Docket Number:	19-AB-2127
Project Title:	Implementation of AB 2127 Electric Vehicle Charging Infrastructure Assessments
TN #:	236963
Document Title:	SDG&E Comments - on AB 2127 Draft Report
Description:	N/A
Filer:	System
Organization:	SDG&E
Submitter Role:	Public
Submission Date:	3/3/2021 1:41:21 PM
Docketed Date:	3/3/2021

Re: San Diego Gas & Electric Comments on AB 2127 Electric Vehicle Charging Infrastructure Assessment

AB 2127 Report: Projected 2030 PEV Load Forecast, Page 33

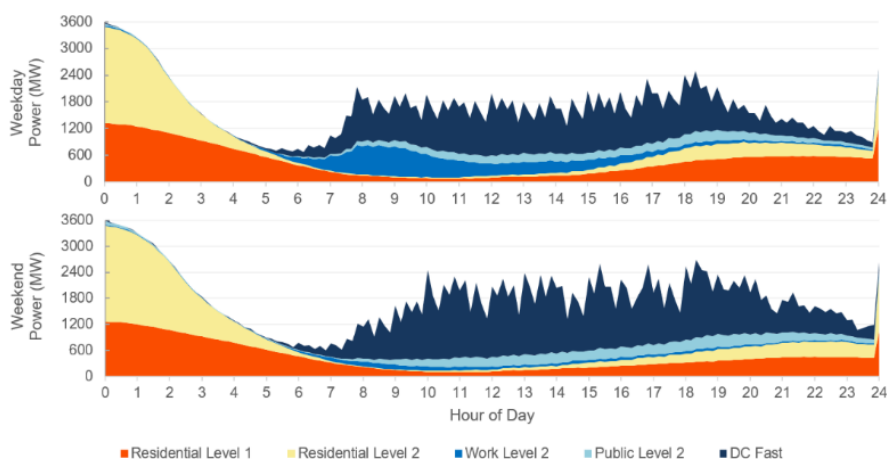
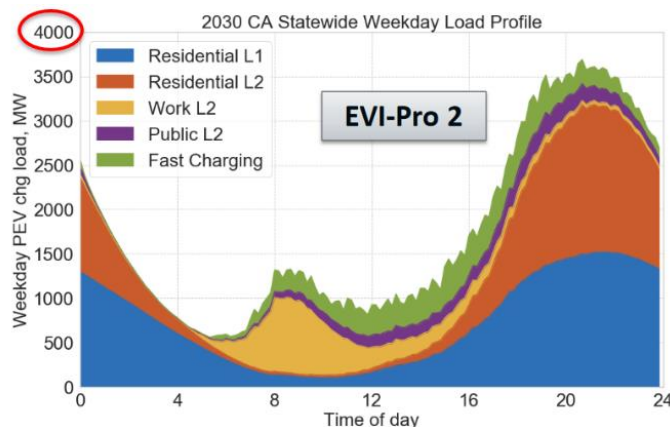
The CEC should include clearer and stronger identification of the variability of load impacts from modeling results

Figure 14 of the AB 2127 Assessment updates a tremendously critical analysis that the CEC has pioneered and led for years on forecasted load impacts of plug-in electric vehicle (PEV) charging. The iteration featured in the present AB 2127 Assessment unveils significant and exciting updates from previous iterations. Most notably, the overall load shape has shifted, with peak moving from roughly 8 pm to midnight. Further, the bi-modal second peak, at roughly 8 am, is no longer present. (See figures below for reference.) As noted in the AB 2127 Assessment, this underscores the importance of the innovative rates passed by SDG&E and other utilities.

The fact that there are such updates to the forecasted load impacts reflects two important characteristics: (1) the industry's understanding of charging behavior is just as nascent as the market itself and (2) charging behavior is subject to meaningful changes based on market developments. Accordingly, SDG&E suggests contextualizing this analysis to show how estimates have changed over time. The load forecasts will inherently communicate that significant adaptation is necessary to support charging infrastructure without any context. However, by providing proper context, the broader audience will understand that continual market analysis and appropriate policy support, such as utility rates, can (and have) positively influenced charging behavior.
